UPGRADED S3 BACKREST

Effective from 2 October 2017, Panthera will be progressively upgrading the backrest on its S3 models..

UPGRADED S3 BACKREST

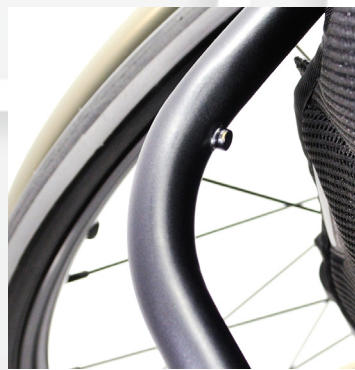
This is to better secure the push handle attachment and reinforce the connection of the crossbar to the backrest tubing.

Please note that only the new version of the push handle and torso support attachment and can be mounted on this backrest. , see [info sheet 2017-14](#) and [info sheet 2017-18](#)

The price for the upgraded backrest will remain the same, but can be identified by the "ver.2" suffix on the label of the backrest frame and to the art.no.
